FIELD CHANGE ORDER

Number: RA81X-I-013

Problem/Symptom: The adhesive used to attach the gaskets to the spindle air filter assembly breaks down at the upper end of the drive operating specification. This causes head to disk interference to occur.

HDA REPLACEMENT FCO

QUICK CHECK FOR RA81X-F-009

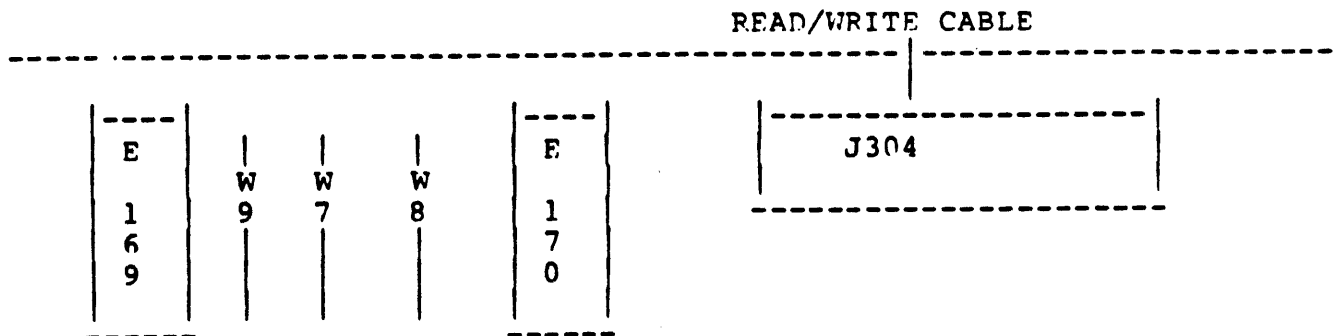
PRESENCE OF 0.1 UFD CAPACITOR AT LOCATION C29 AND 38.3 OHM PRECISION RESISTOR (ORANGE-GRAY-ORANGE) AT LOCATION R64. RA81X-S-004, R/W MODULE (54-15253) MUST BE AT CS REVISION LEVEL "D" BEFORE INSTALLATION OF THIS FCO. PROBLEM - HIGH RATE OF ERROR CODES 62 AND/OR 63. INTERMITTENT, UNEXPLAINED BURSTS OF ECC ERRORS.

Figure 6 **PRELIMINARY**
 SUB PAGE WITHOUT NOT

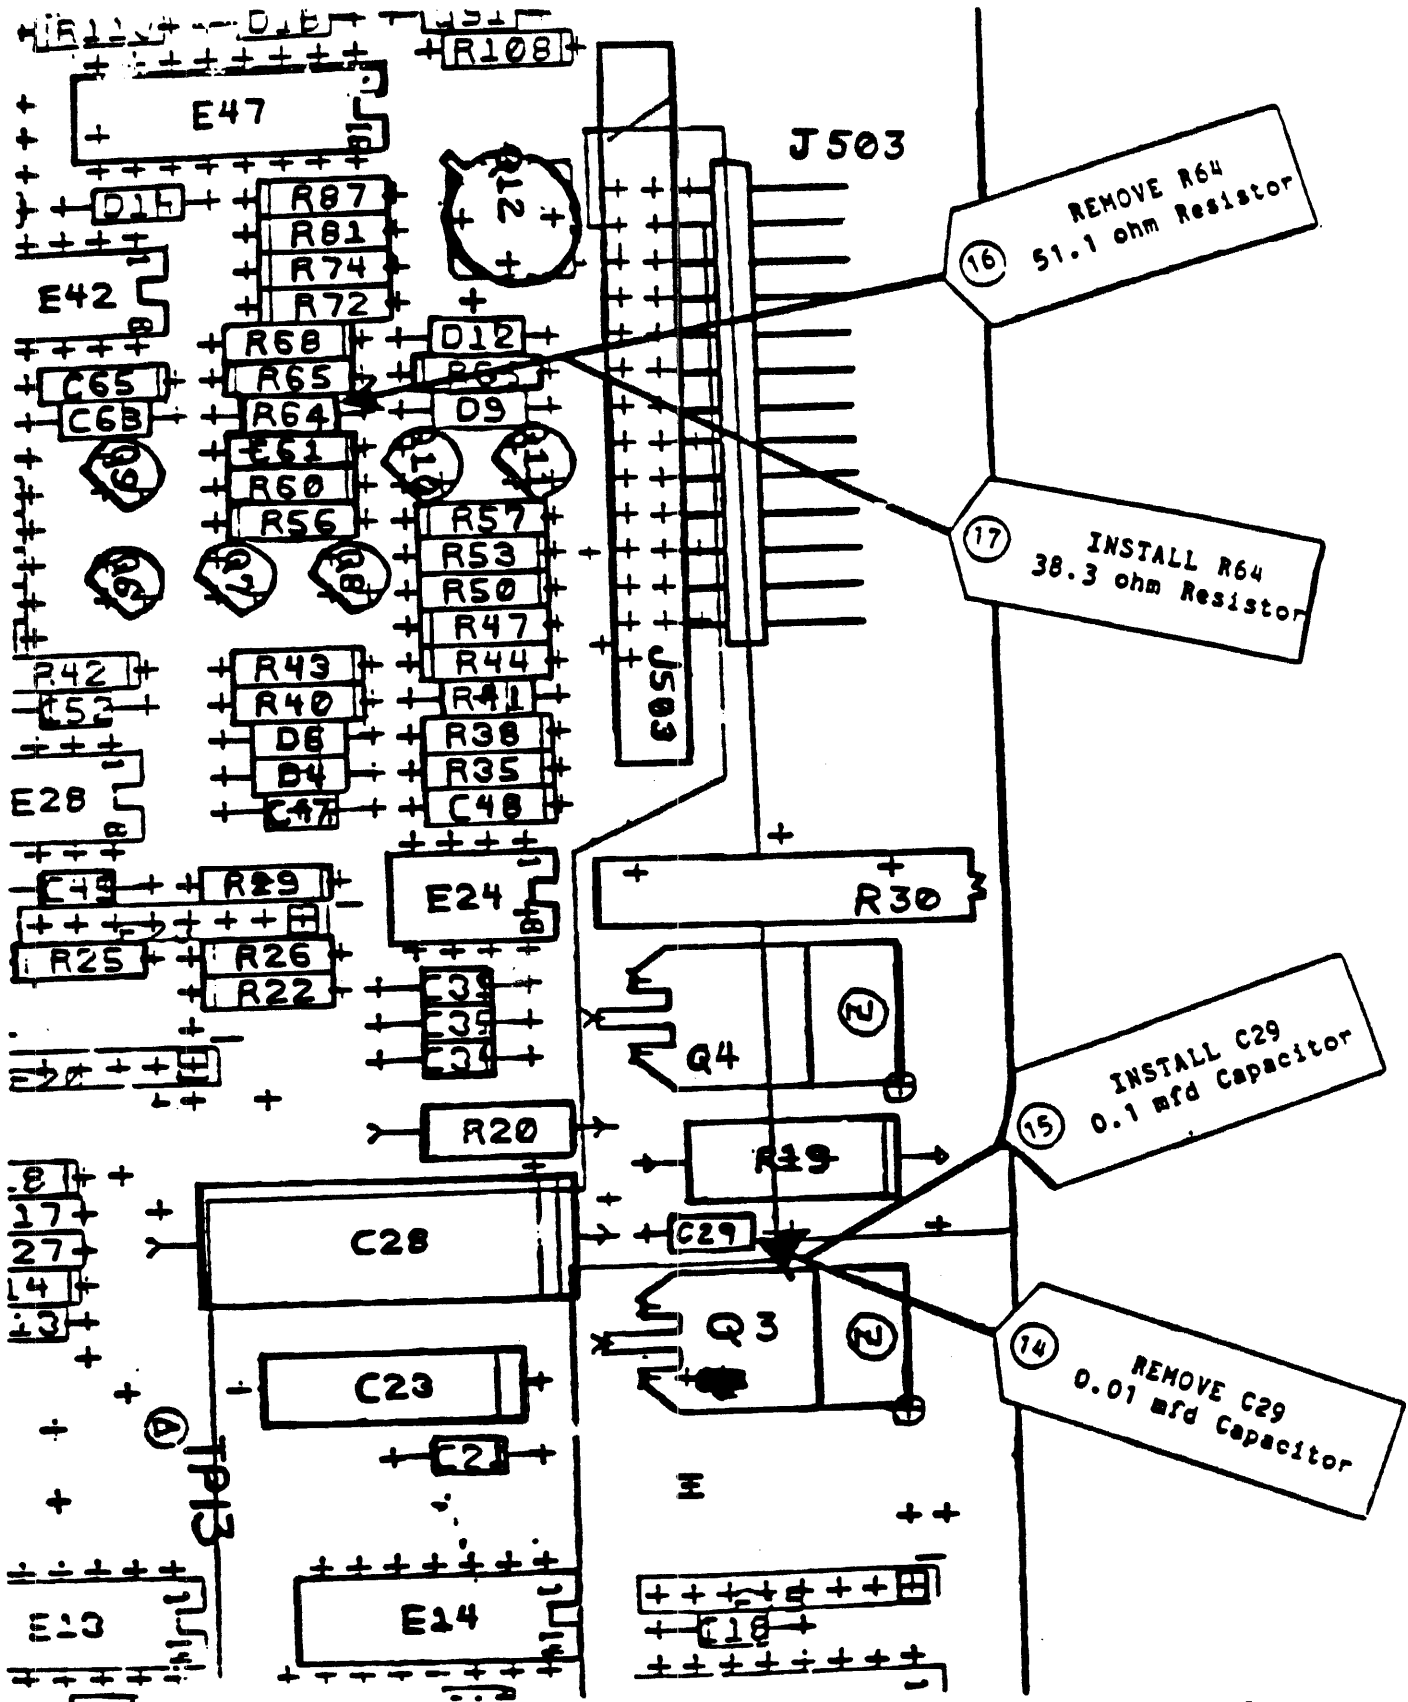
17. Remove R64 (51.1 ohms, 1/4 watt, 1%, resistor). Refer to Figure 6. This resistor may be identified by the marking "51R1" OR color-coded with the color bands "Green-Brown-Brown-Gold-Brown".
18. Install R64 (38.3 ohms, 1/4 watt, 1% resistor, p/n 13-05121-00) supplied in the FCO Kit. Refer to Figure 6. This resistor may be identified by the marking "38R3" OR color-coded with the color bands "Orange-Grey-Orange-Gold-Brown".
19. When the above rework is complete, mark the module "CS Revision F1".
20. Re-Install the reworked R/W module back into the drive.
21. Lower the drive chassis until the chassis latch engages.
22. If the drive is fixed mounted (top drive), proceed to rework step 25.
23. Push in on Slide Arm "B" and slowly slide the drive back into the cabinet. (Figure 3)

Figure 6
JUMPER LOCATIONS

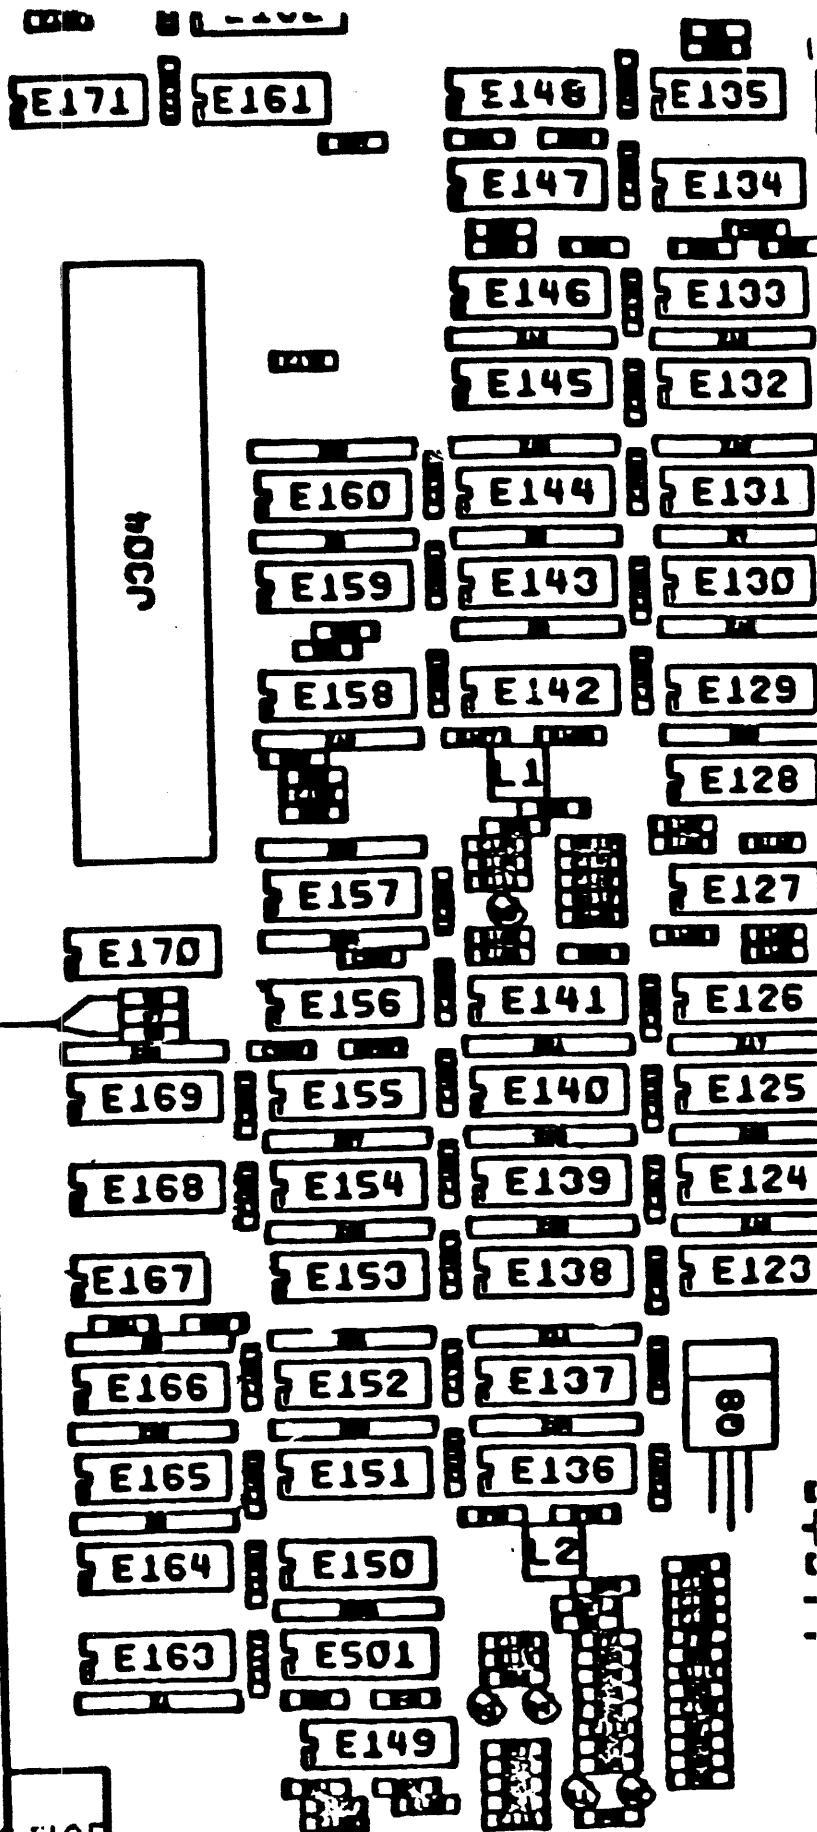
1. THE JUMPERS ARE LOCATED ON THE MICROPROCESSOR MODULE. (Figure 6)
2. FOR PROPER JUMPER POSITION, LOCATE W7, W8, and W9, see Figure 7.
3. VERIFY THE CURRENT JUMPER SELECTION

CURRENT SETTING	CHANGE	RESULT
W9, W8, W7 OUT	ADD W9	W9 IN
W9 IN / W7, W8 OUT	ADD W8	W8 W9 IN
W8 IN / W7, W9	ADD W7 AND W9 REMOVE W8	W7 W9 IN
W9 AND W8 IN / W7 OUT	ADD W7 REMOVE W8	W7 W9 IN

FIGURE 7

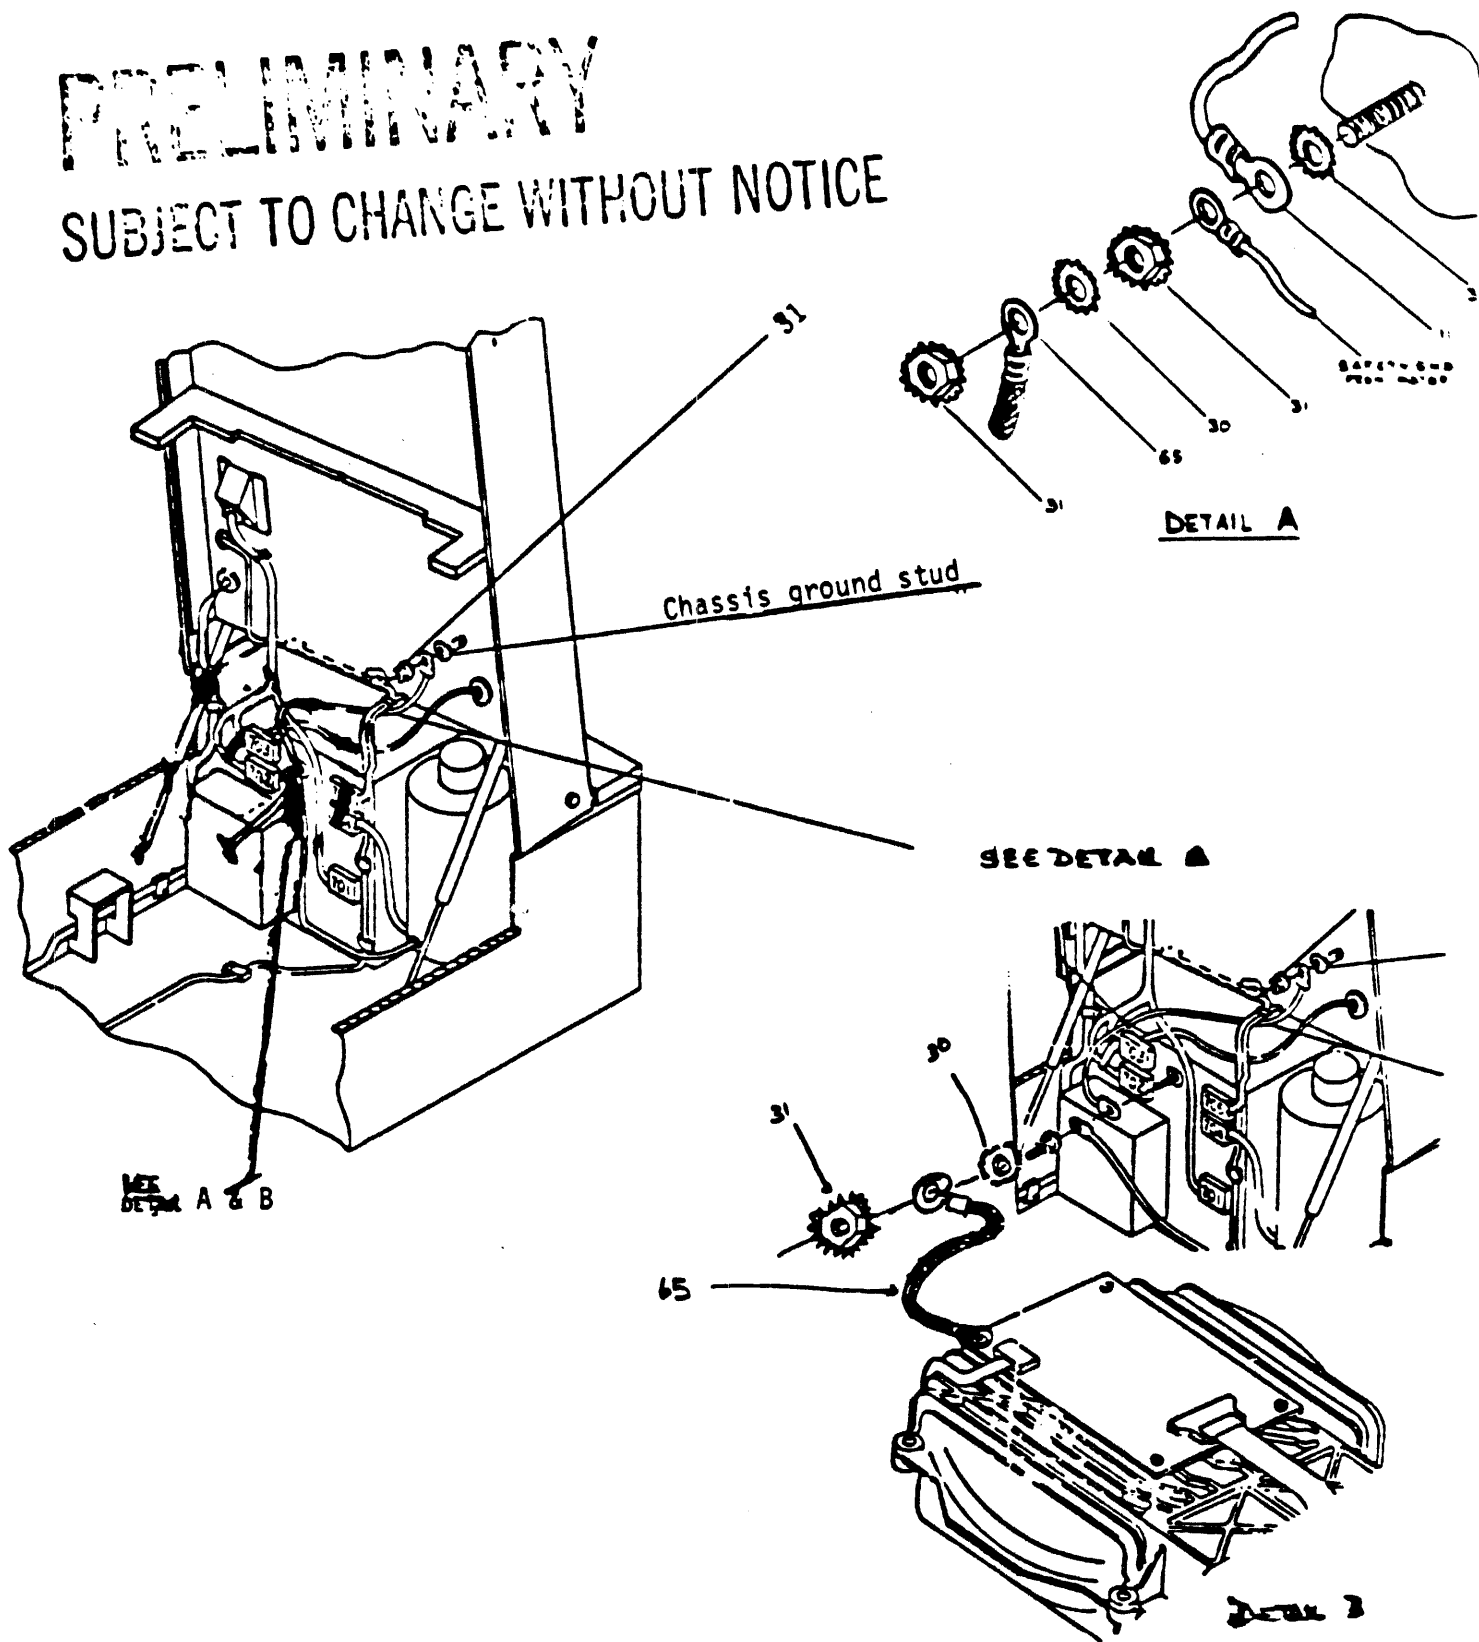
20. Attach the other end of the Ground Strap to the Power Supply ground stud using the Kept Nut and Star Washer supplied in the EQ Kit (SEE DETAIL A and B of FIGURE 7).

FIGURE 8

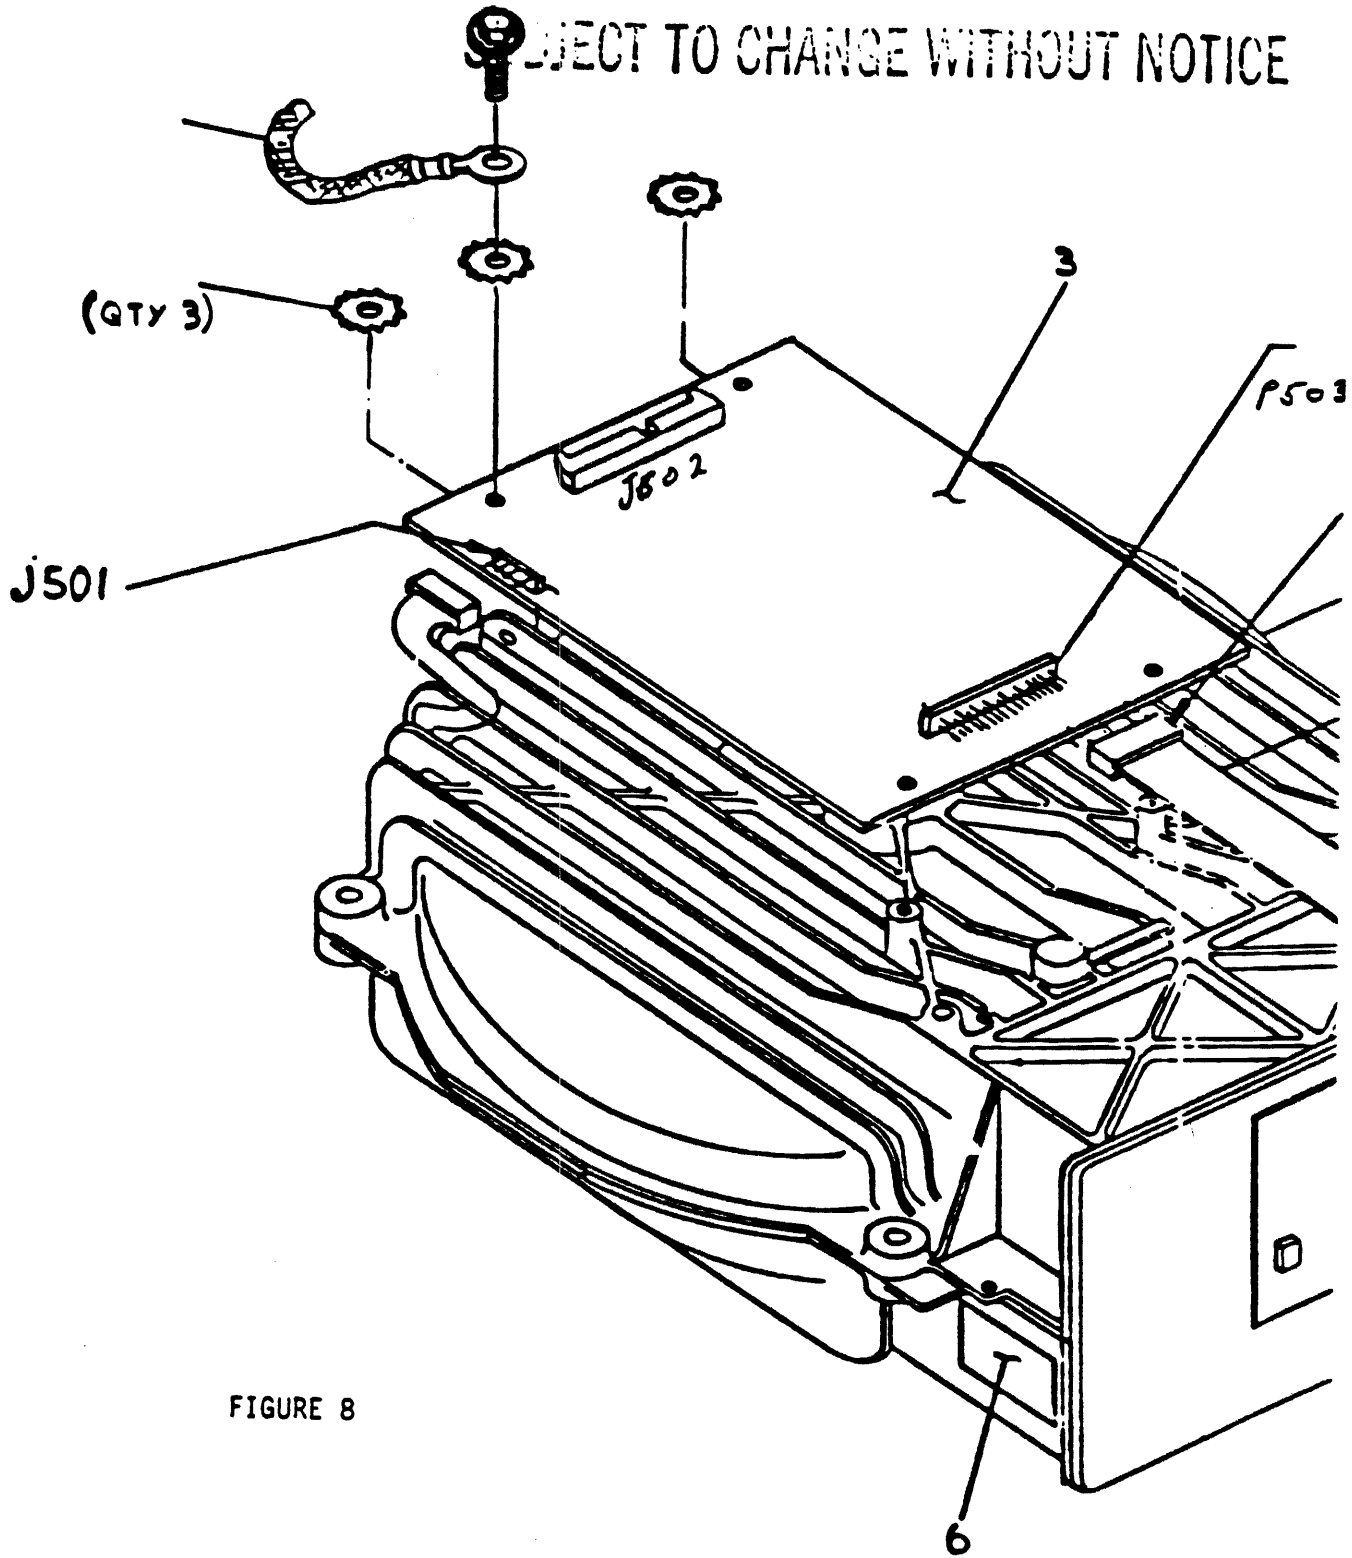
15. Place one Star Washer (90-08151-00) under the left and right mounting standoff (FIGURE 8).
16. Lay the Read/Write back in place, and attach the two front hold down screws using the Longer Screws (90-10075-01) supplied in the F.C.O. EQ Kit.

17. Insert the Longer Screw through one end of the HDA Ground Strap (12-25629-01) (FIGURE 8).
18. Place one Star Washer (90-08151-00) on top of the left rear Read/Write module grounding pad (FIGURE 8).

19. Attach Ground Strap, Longer Screw, and Star Washer to the left rear Read/Write module hold down. Insure that the lower Star Washer is still in place (FIGURE 8).

HARDWARE REVISION LEVEL SWITCHES FIGURE 9

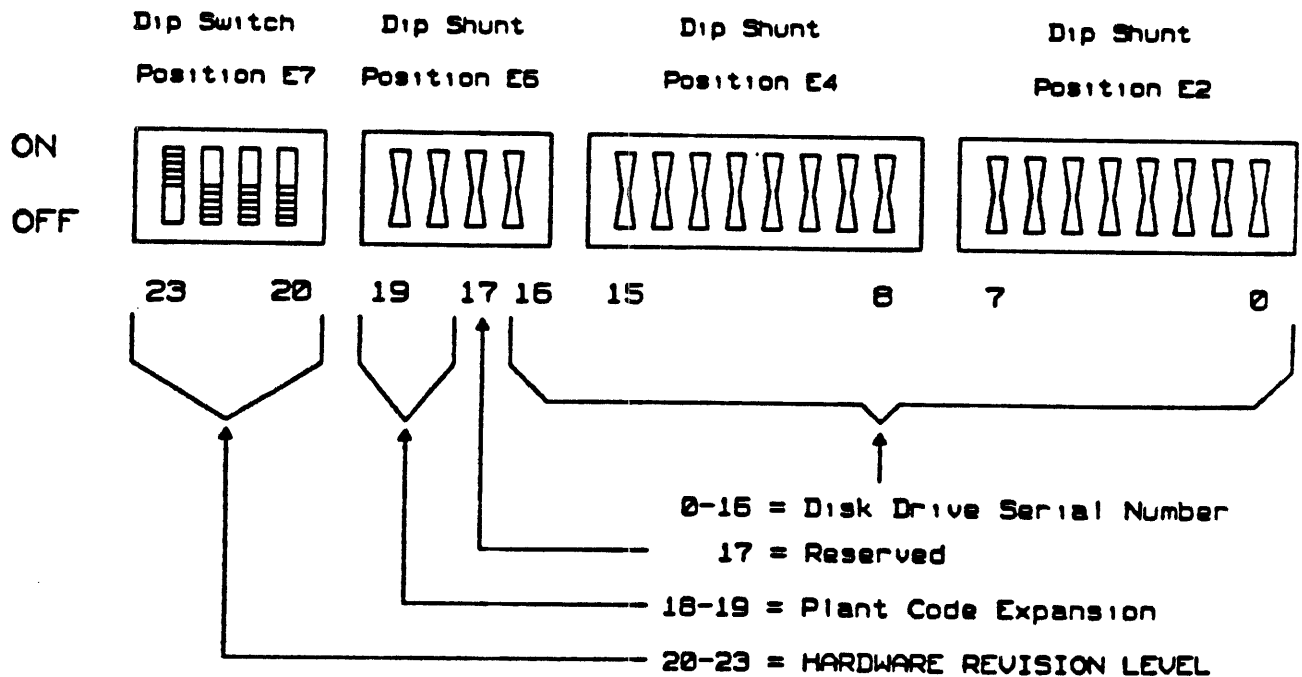
21. Close the logic chassis, DO NOT SLAM SHUT - HDA DAMAGE MAY OCCUR.
22. The Hardware Revision level switches are to be changed to seven (7). Remove the front bezel by removing the upper and lower mounting screws from each side of the drive (FIGURE 10).

23. Remove the Operator Control Panel from the Bezel (FIGURE 11) and change the switches to reflect a hexadecimal seven (7) (FIGURE 9).
24. Replace the front bezel cover.

Set the DIP SWITCHES for the Hardware Revision Level on the Operator Control Panel (54-14927) to the indicated positions:
